**U.S. NUCLEAR REGULATORY COMMISSION**  
**FINAL SAFETY EVALUATION FOR**  
**TOPICAL REPORT WCAP-16996-P/WCAP-16996-NP, VOLUMES I, II, AND III, REVISION 1,**  
**“REALISTIC LOSS-OF-COOLANT ACCIDENT EVALUATION METHODOLOGY**  
**APPLIED TO THE FULL SPECTRUM OF BREAK SIZES” (TAC NO. ME5244)**  
**WESTINGHOUSE ELECTRIC COMPANY**  
**PROJECT NO. 700**

Figure 1: A Characteristic PCT Response to Break Size Variation Observed in Analyses Using 10 CFR Part 50 Appendix K and in Power Uprate Small Break LOCA Analysis

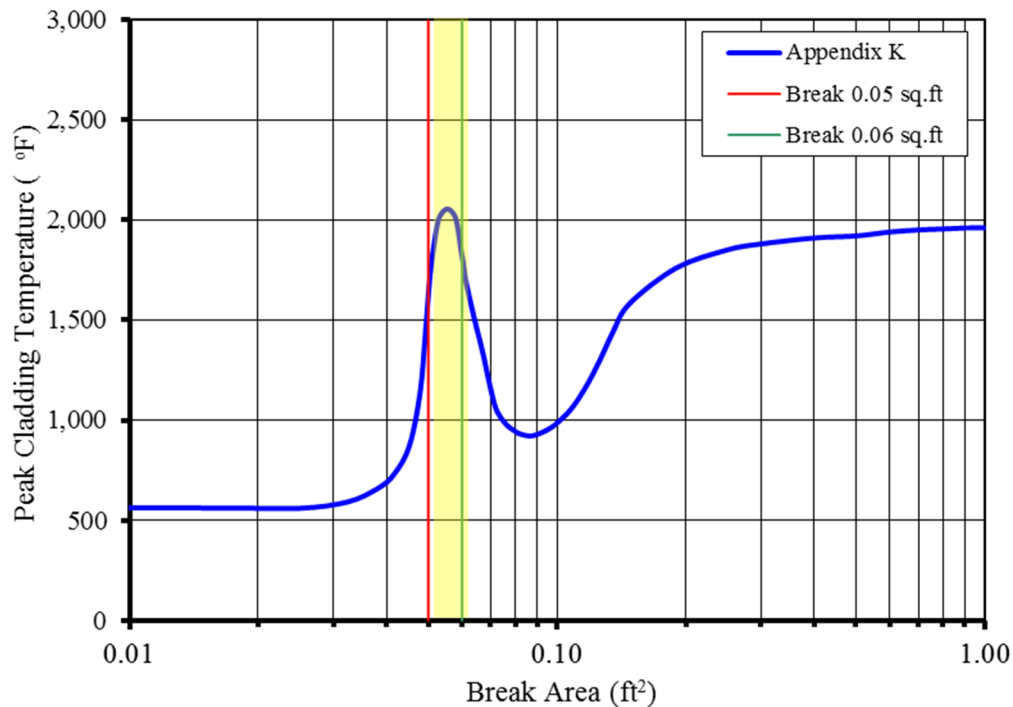
A typical small break spectrum analysis produces a characteristic PCT versus break size response, which is shown in Figure 1. Of particular significance in this response is the observed limiting break region with a maximum in the PCT at approximately 0.055 ft<sup>2</sup>. The depicted PCT vs break size curve is typical of plants with low capacity high pressure safety injection pumps or those undergoing extended power uprates. It is important to further note that for some plants the predicted PCT can increase by a few hundred degrees Fahrenheit when the break size changes within the limiting break region from approximately 0.05 ft<sup>2</sup> to 0.06 ft<sup>2</sup>. For example, it has been observed for many PWR plants that the PCT can increase by ~100 °F when the break area changes by as little as 0.005 ft<sup>2</sup> within this break region so that the PCT at a 0.055 ft<sup>2</sup> break is considerably higher than the PCTs at both 0.05 ft<sup>2</sup> and 0.06 ft<sup>2</sup> breaks. Furthermore, this limiting break region is characterized by a RCS pressure that depressurizes to a pressure value just above the safety injection tank (SIT) or accumulator actuation pressure. Because such behavior characterizes a large number of PWR plants, it is necessary to resolve the limiting break region confining the worst break controlled entirely by the high pressure injection pump. The core uncover period for breaks in this limiting range of relatively small breaks can be as long as 45 minutes to one hour. For some plants, the two-phase mixture level in the core can recede slowly to depths near the core mid-plane during this period. Such long term core uncover LOCAs emphasize the significance of the BE two-phase level swell modeling and PCT, controlled by interfacial drag, steam cooling heat transfer, loop seal clearing behavior, decay heat, and condensation at the safety injection port, to name the most significant. Clearly, with the core being uncovered for a period of up to one hour, very small changes in the core two-phase mixture level during such uncover periods can result in very large PCT changes.

Given the above discussed issues and the fact that the WCOBRA/TRAC-TF2 code has no proven history of successful simulation of SBLOCAs, the NRC staff formulated the following approach to identifying and analyzing the limiting break region for the SBLOCA spectrum as illustrated in Figure 1. The entire small break spectrum (Region I) is defined as:

In general, the limiting break region will lie between 2 inches and 4 inches in equivalent break diameters in the cold leg, but may differ slightly due to plant power level, geometry, and ECCS characteristics. [

To provide adequate resolution, a large number of runs, using diameter increments of 0.1 inch, for example, are to be performed for small break sizes between 2 inches (0.0218 ft<sup>2</sup>) and 4 inches in diameter (0.0873 ft<sup>2</sup>) [ ] The analysis of this 2- to 4-inch diameter limiting break range should be conducted using the approach [ ] with some additions that include the following assumptions specific to Region I analysis.
